COUNCIL ASSESSMENT REPORT

NORTHERN REGIONAL PLANNING PANEL

PANEL REFERENCE & DA NUMBER	PPSNTH-142 – DA21/0949
PROPOSAL	Senior's housing including demolition of existing dwellings and construction of 95 units, a swimming pool, signage, lot consolidation and tree removal
ADDRESS	Lot 113 DP 237806; 6 Powell Street, Tweed Heads; Lot 114 DP 237806; 8 Powell Street, Tweed Heads; Lot 115 DP 237806; 10 Powell Street, Tweed Heads; Lot 116 DP 237806; 12 Powell Street, Tweed Heads; Lot 117 DP 237806; 33 Florence Street, Tweed Heads; Lot 118 DP 237806; 35 Florence Street, Tweed Heads; and Lot 119 DP 237806; 37 Florence Street, Tweed Heads
APPLICANT	Zone Planning
OWNER	THRV Pty Ltd
DA LODGEMENT DATE	2 December 2021
APPLICATION TYPE	Development Application (Integrated)
REGIONALLY SIGNIFICANT CRITERIA	Section 2.19, Schedule 6 of the Planning Systems SEPP: development that has a capital investment value of more than \$30 million.
CIV	\$53,153,800.00 (excluding GST)
CLAUSE 4.6 REQUESTS	Tweed City Centre Local Environmental Plan 2012 – Section 4.3 Height of Buildings; Tweed City Centre Local Environmental Plan 2012 – Section 4.4 Floor Space Ratio.

Figure 9: Privacy screen provided to unit 514 (Level 4) and to the same unit on all other levels

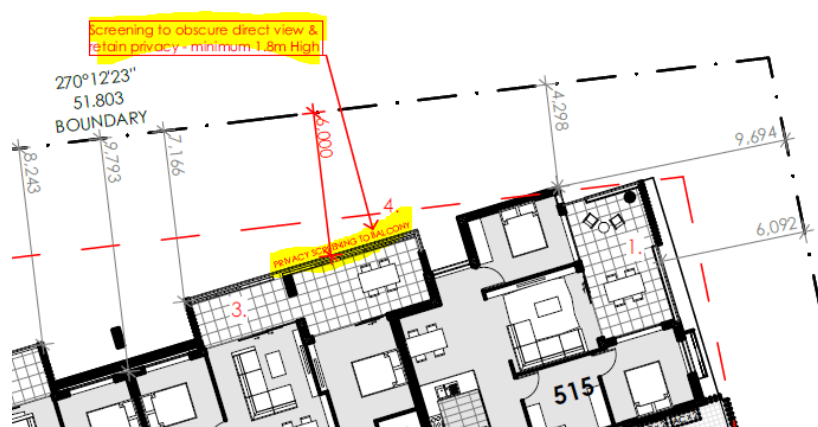
Whilst the north-eastern corner of the proposed development does not meet the minimum setback required of 8m, visual and acoustic privacy to the adjoining development to the north, being No. 3 Ivory Place is retained due to the inclusion of a privacy screen to the balcony of north-facing units – see **Figure 9** below.

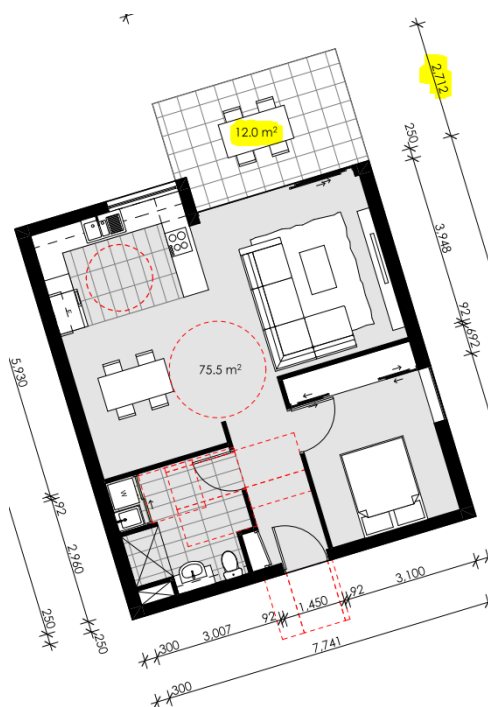
In respect of the proposal, as amended, 70% of the dwellings equates to 67 units. Amended plans received 15 February 2023 note 68 units, or 71.5% of units receive 2 hours of solar access, including three (3) south facing units located on Level 5 (being units 606, 607 and 608).

Council does not consider these three (3) units to achieve compliance with the standard, and that the proposal achieves compliance for 68.4% of units. Nevertheless, as discussed later in this report, the variation has been accepted.

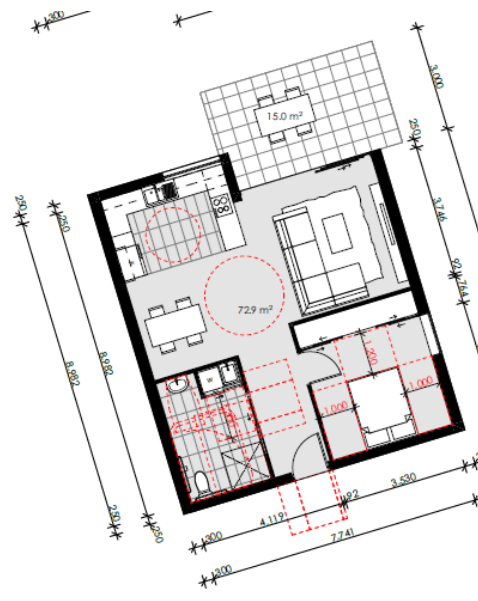
As part of the amended plan set received 15 February 2023, the applicant provided layout plans for unit types K-1, K-3, K-4 and K-5, as requested by Council.

Unit types K-1, K-4 and K-5 did not comply with either 8(b)(i) or (ii) whilst unit type K-3 failed to comply with 8(b)(ii).

The non-compliance was raised with the applicant on 14 March 2023, noting no justification for the non-compliance had been provided and any such variation to the development standard would not be supported.

Figure 12: Indicative plans showing compliance with s8(b)(i) and (ii) achievable for Unit Types K-4 and K-5

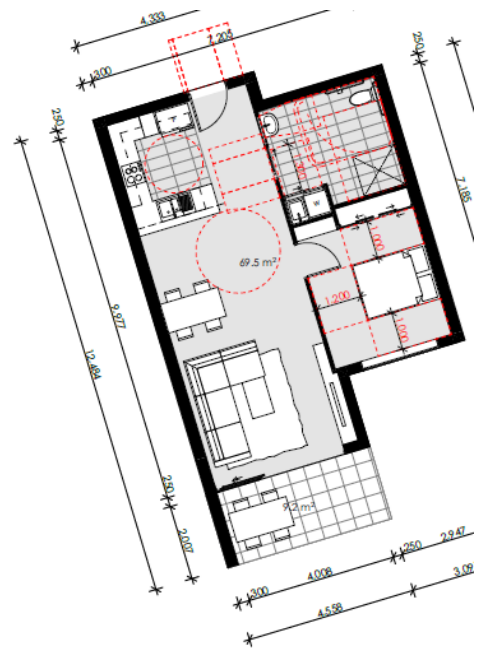
On 16 March 2023, the applicant submitted indicative plans which demonstrate that compliance with the development standard could be achieved for each of the noted unit types – see **Figures 11 and 12** below.

As the applicant has shown compliance can be achieved without compromising any other requirement, the issue is considered to be resolvable via a Deferred Commencement condition of consent requiring amended plans showing compliance with the development standard to be submitted. This condition has been recommended.

Figure 13: Indicative plans showing compliance with s19(c) achievable for Unit Type C-1 (shown highlighted yellow)

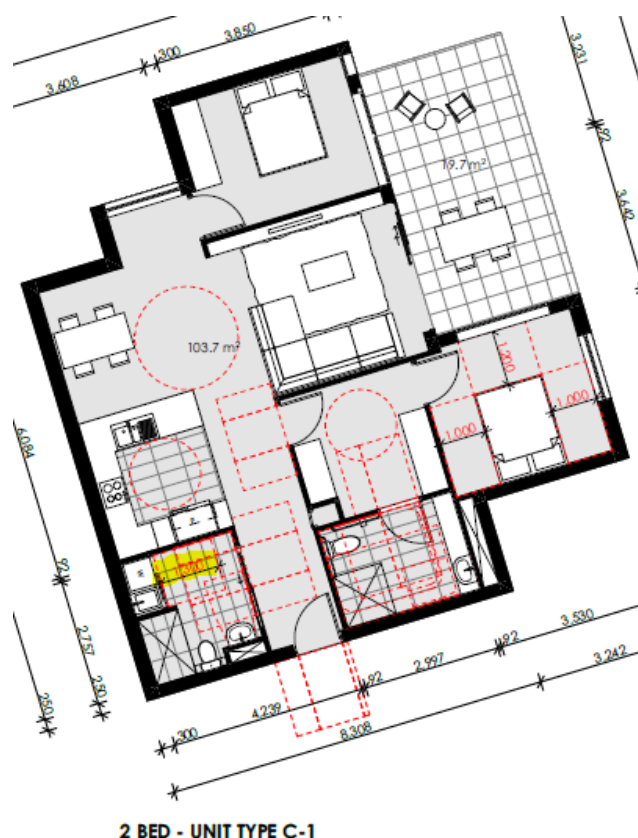
The non-compliance was raised with the applicant on 14 March 2023, noting no justification for the non-compliance had been provided and any such variation to the development standard would not be supported.

On 16 March 2023, the applicant submitted indicative plans to demonstrate that compliance with the development standard could be achieved for each of the noted unit types – see **Figures 13 and 14** below.

As the applicant has shown compliance can be achieved without compromising any other requirement, the issue is considered to be resolvable via a Deferred Commencement condition of consent requiring amended plans showing compliance with the development standard to be submitted. This condition has been recommended.

Figure 17: Ground floor level, as amended, showing vehicle entries and exit include to porte cochere in north western corner, adjacent to Powell Street.

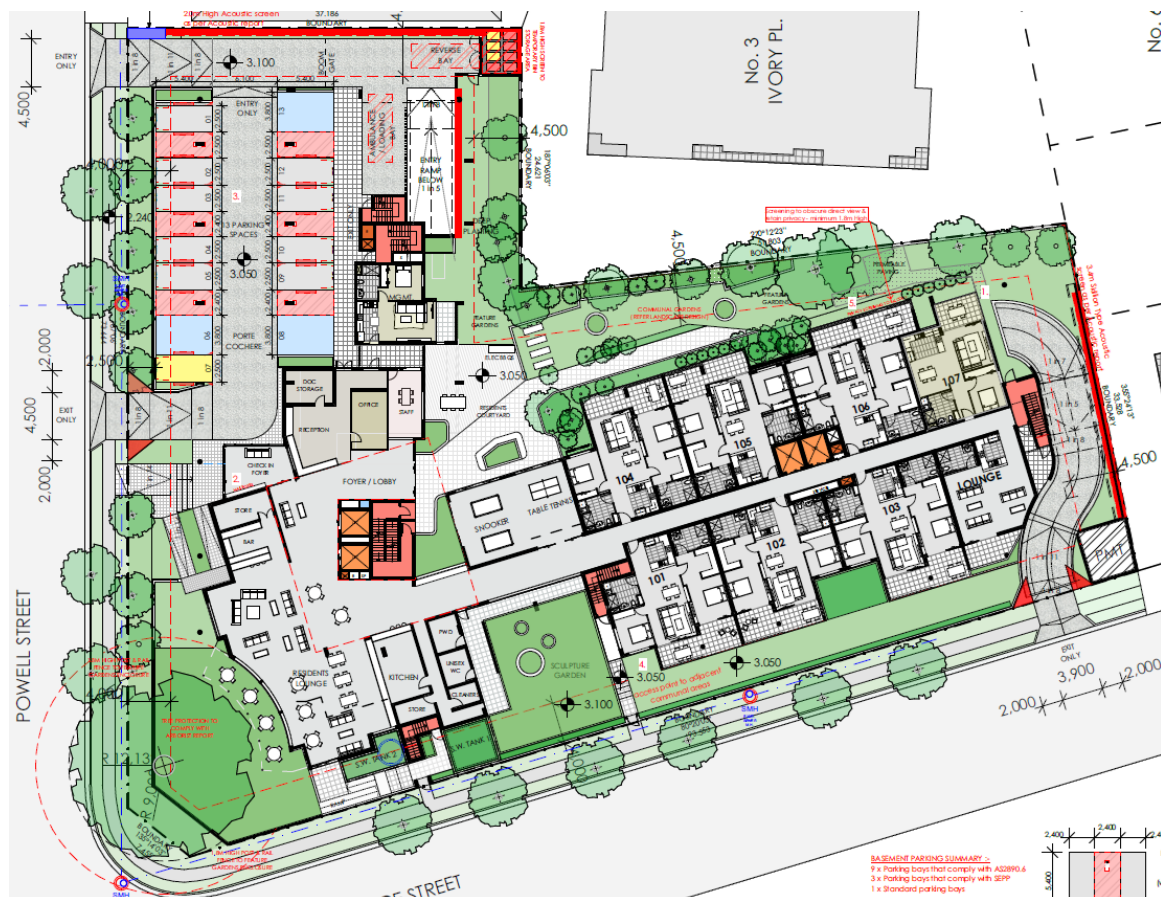
TDGP B2 discourages the use of porte cocheres except in exceptional circumstances. Whilst port cocheres are not encouraged, control 'j' notes that, where the incorporation of a porte cochere is justified, they should be internal to the building with one combined vehicle entry and exit point, or one entry and exit point on two different street frontages of the development.

The porte cochere is considered justified in this instance as the proposal is for seniors housing and it is anticipated people with mobility issues will reside within the provided dwellings. As such, the provision of a porte cochere allows for safe, covered and level access to the main pedestrian entry of the development. The proposal seeks to provide separate vehicle entries and exits as shown in **Figure 17** below which are considered acceptable and is considered to minimise traffic disruption to and from both street frontages.

Whilst porte cocheres are not encouraged, the proposal is considered acceptable in this regard, in this instance.
